DEQ Coal Combustion Residuals Surface Impoundment Closure Determination

Mayo Steam Station

April 1, 2019

CROSS SECTION A-A’ (VIEWED FROM SE SIDE OF CROSS SECTION LOOKING NW)

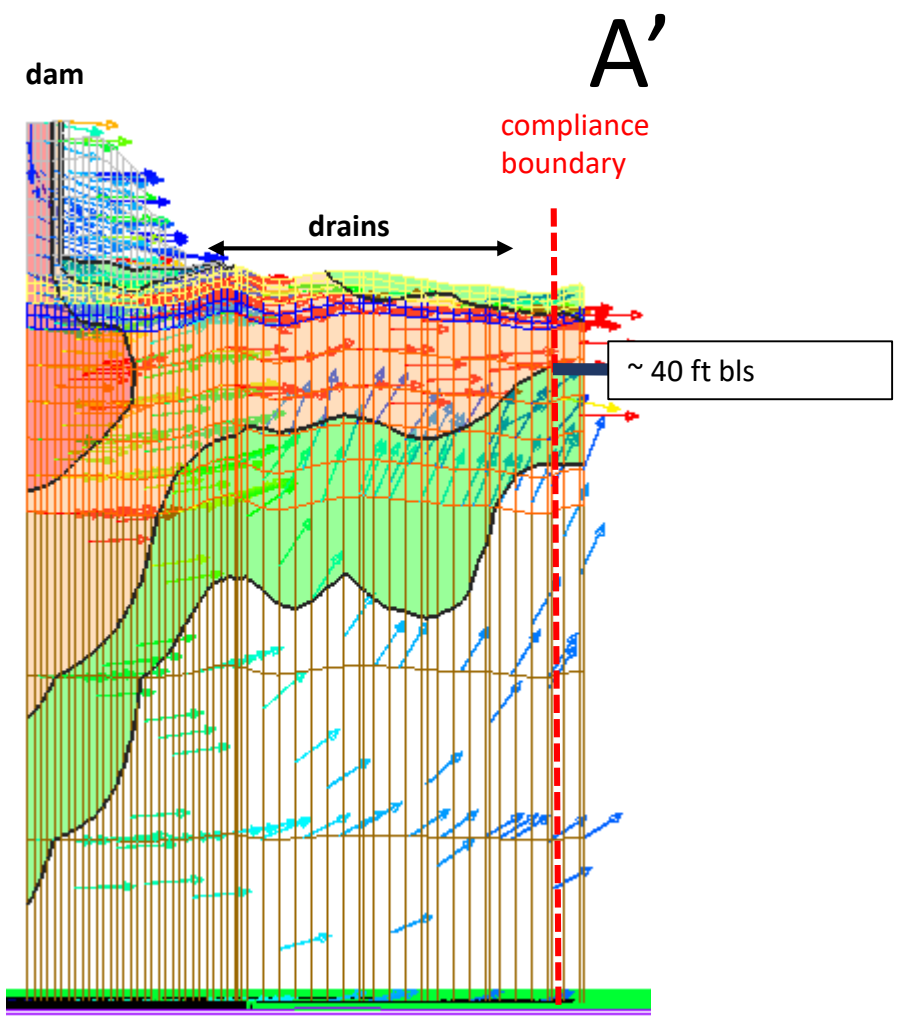
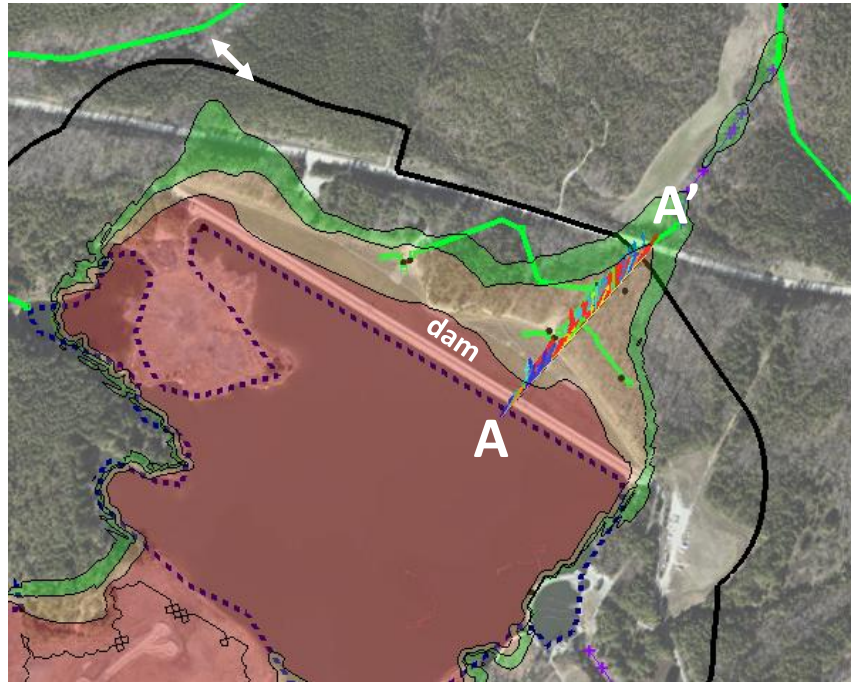
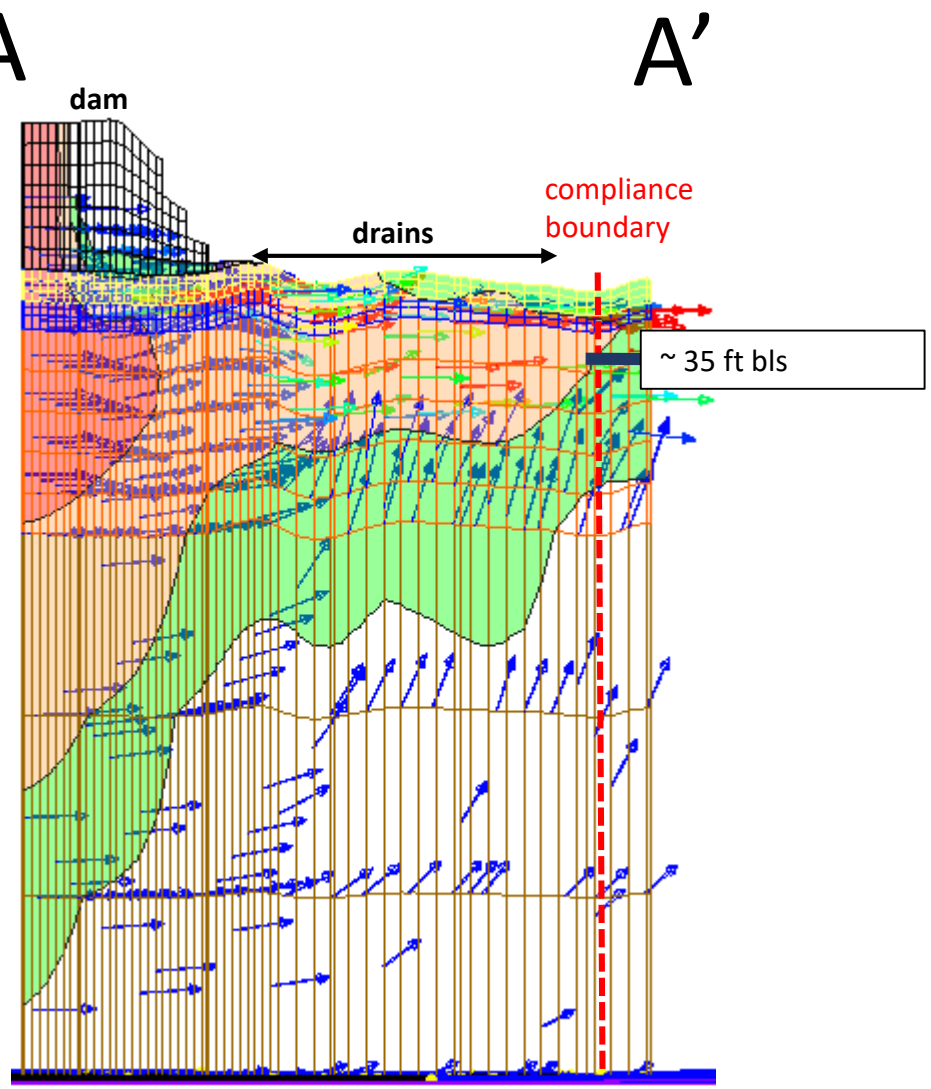
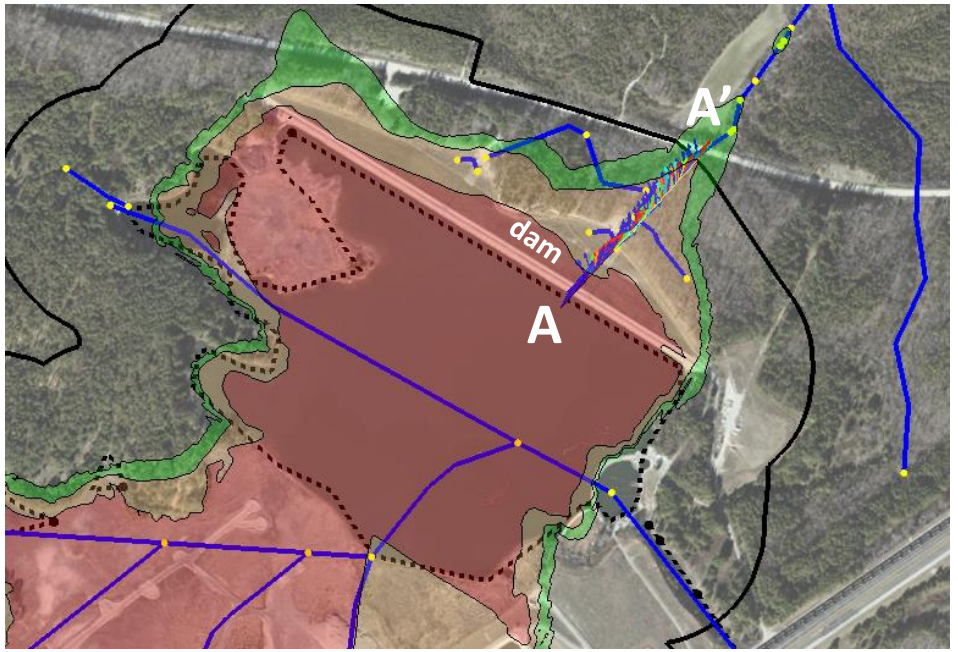
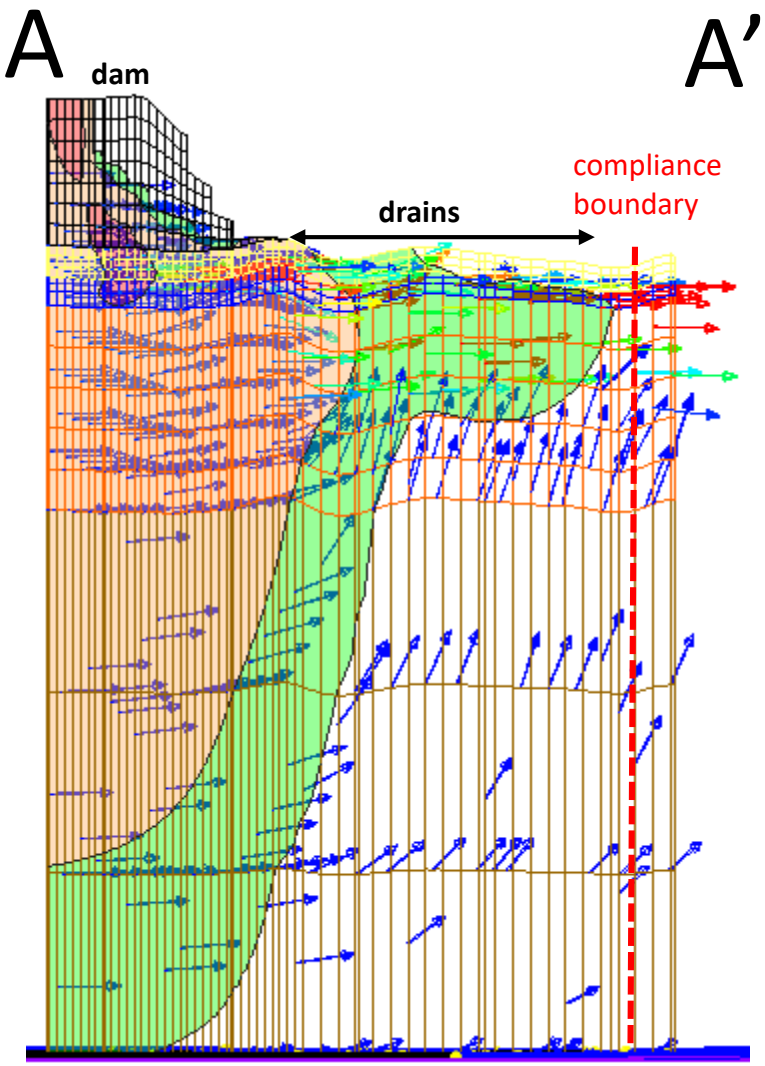
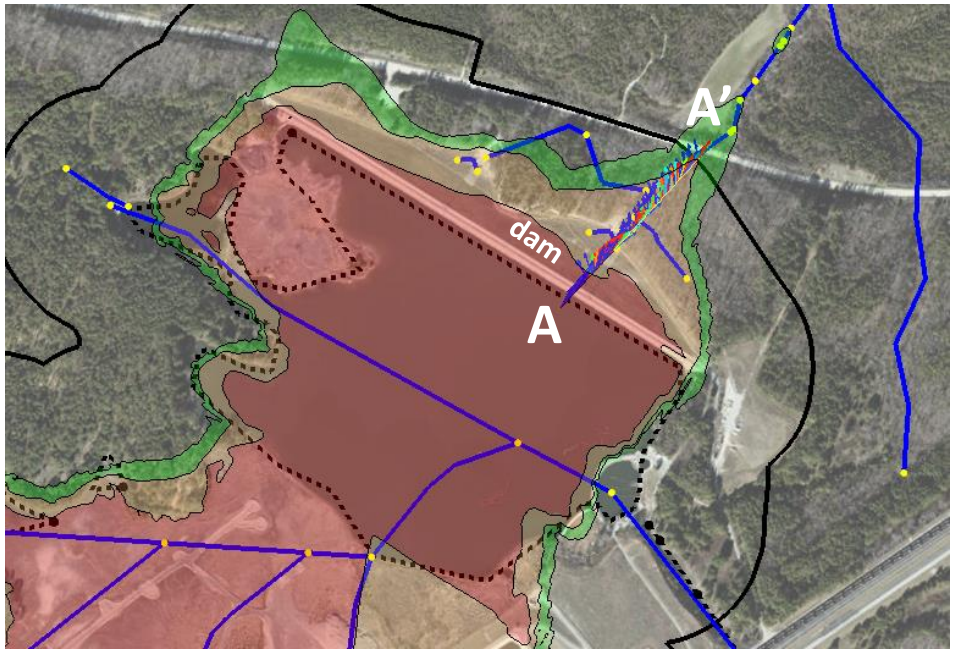
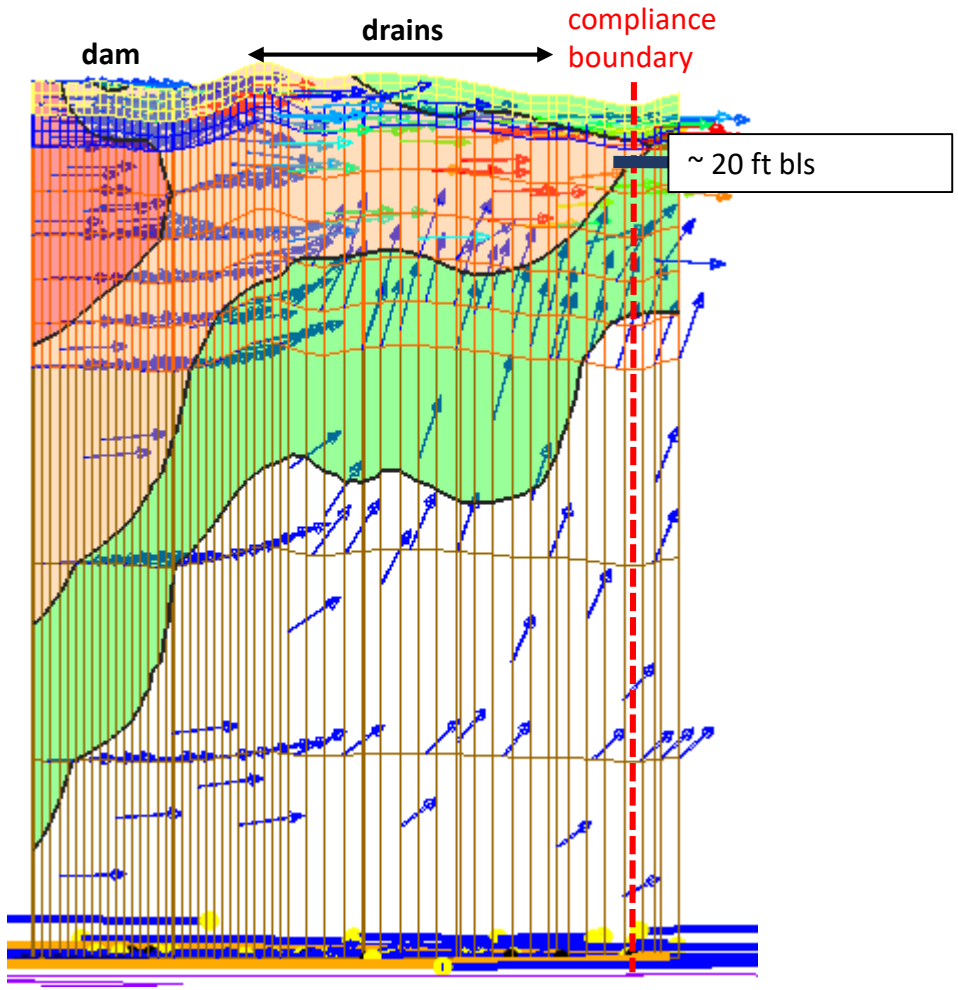
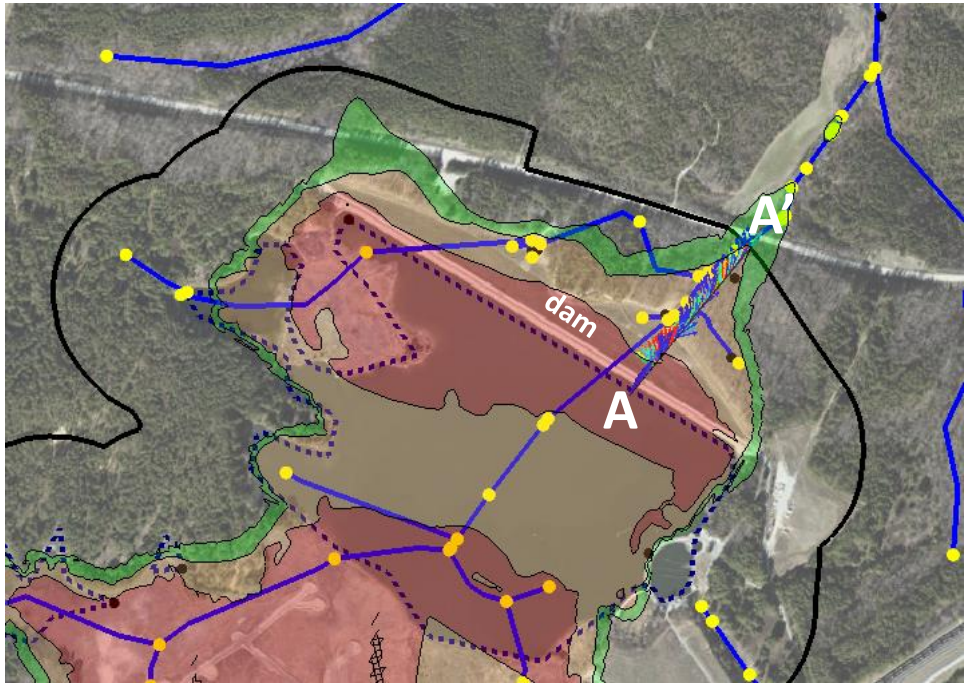
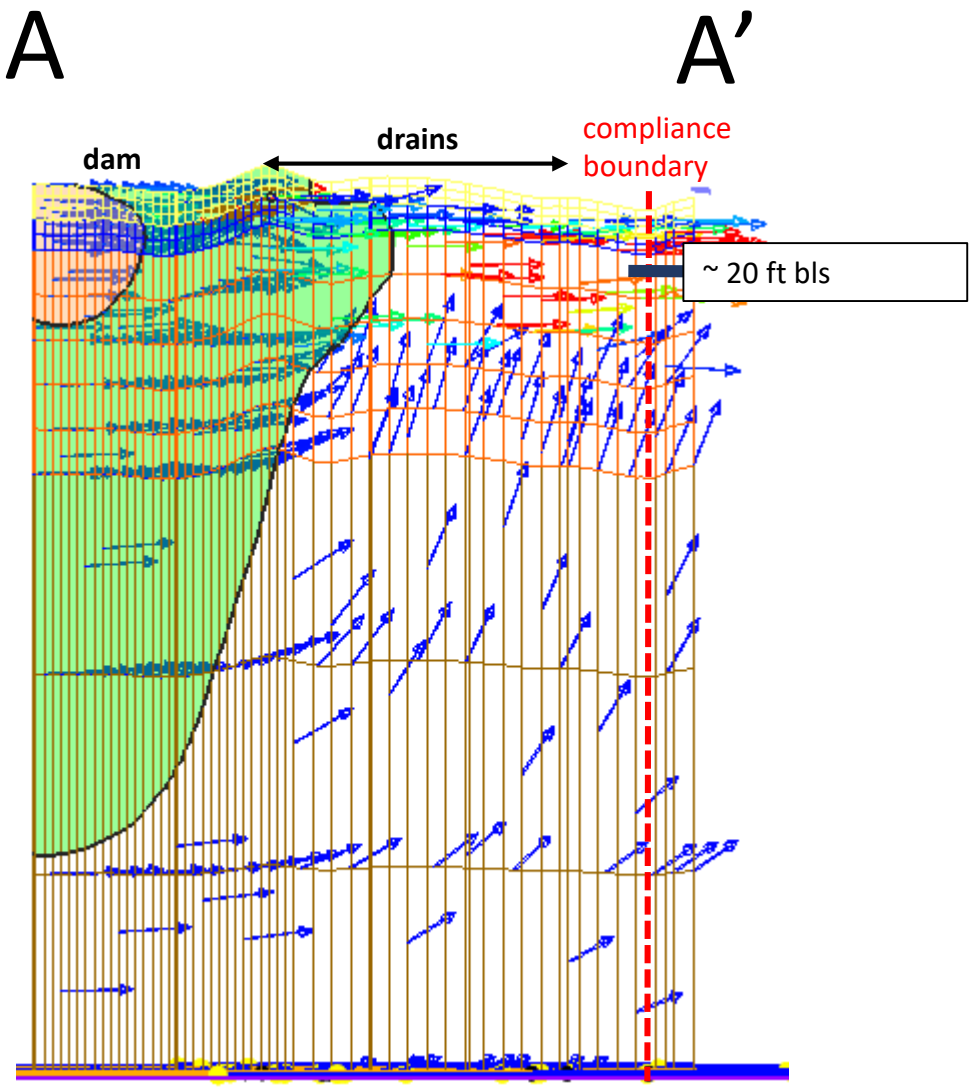
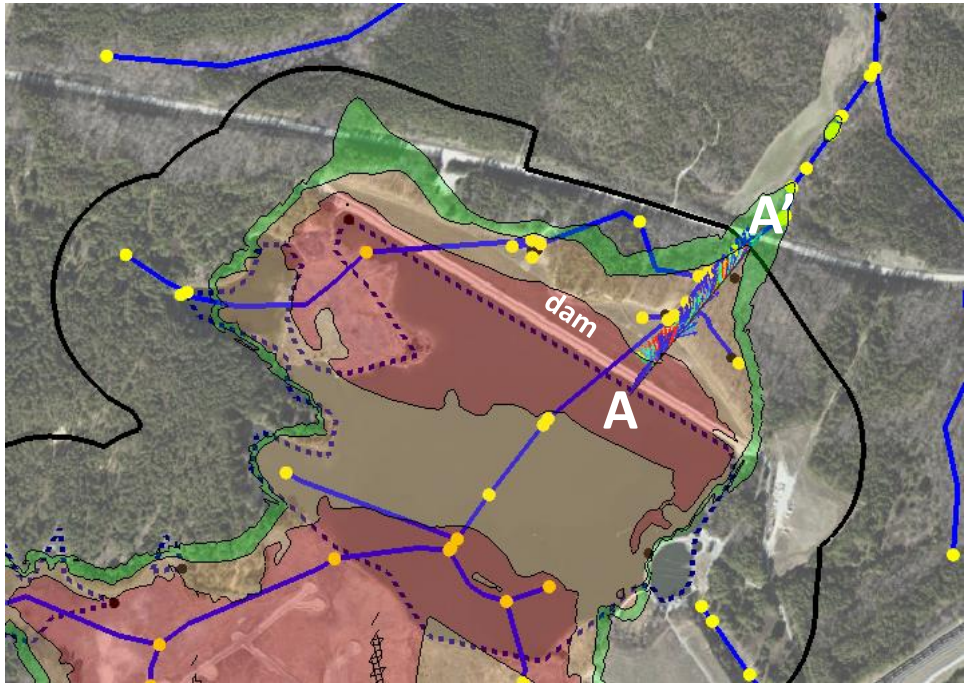
exceedances of the 2L groundwater quality standards (15A NCAC 02L) at the compliance boundary upon the plan's full implementation. Cross section A-A' was evaluated and can be seen in the figures below. This cross section represents where the boron concentration above the 2L standard of 700 µg/L has crossed the compliance boundary based on groundwater monitoring and modeling.
